ABS Sensor Mounting Bracket Contact with Tone Wheel S462, S522 Rear Axles

M-593-001

(September 2007)

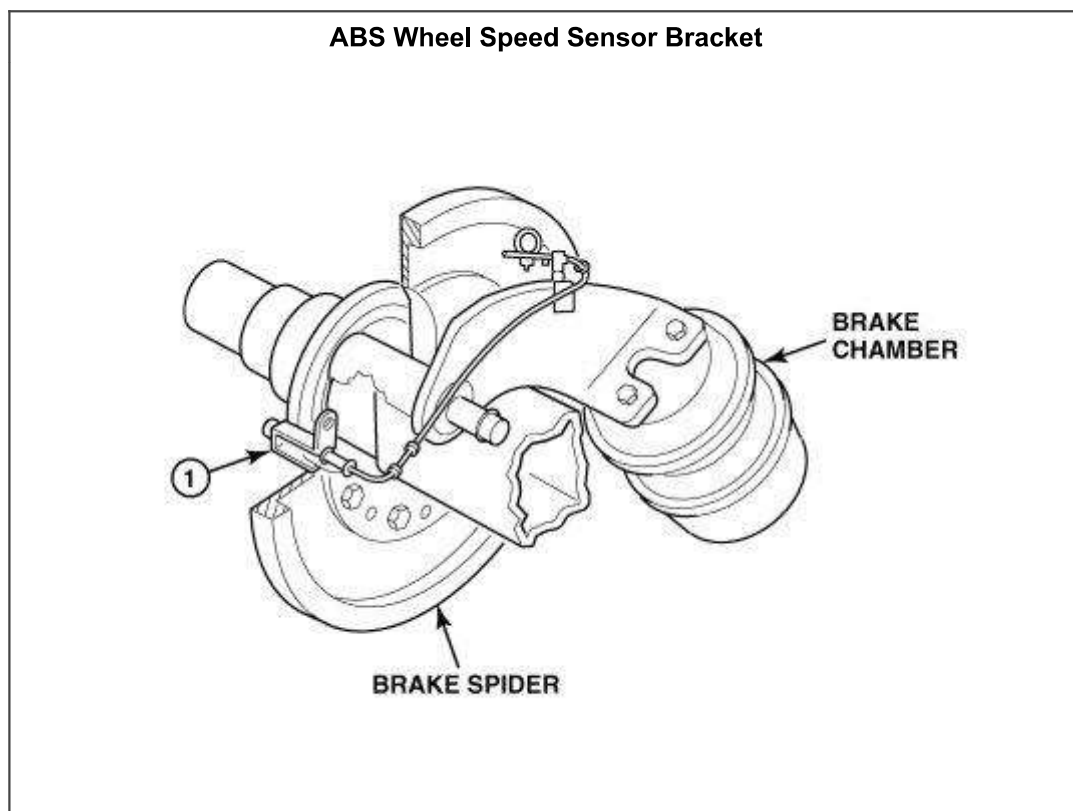
Effective August 29, 2007, a different ABS wheel speed sensor mounting bracket (part No.11MN45M) was implemented into production on all chassis equipped with an S462 or S522 rear axle. This change was made to eliminate an interference condition between the mounting bracket and tone wheel. Should contact between the wheel speed sensor mounting bracket and tone wheel occur, an ABS fault (MID 136, SID/FMI 003/000, 003/008,004/000, 004/008, 005/000 or 005/008, "Sensor Air Gap too Large," or "Air Gap too Large or Sensor Shorted") will be logged. If this condition is encountered on a chassis manufactured prior to August 29, 2007, replace the existing sensor bracket (part number 11MN43M) with bracket part number 11MN45M.

Note: If contact between the wheel speed sensor mounting bracket and tone wheel has occurred, inspect the tone wheel for damage and replace as required.

Key	Part number	Description	Replaces
1	11MN45M	Bracket, ABS wheel speed sensor mounting	11MN43M
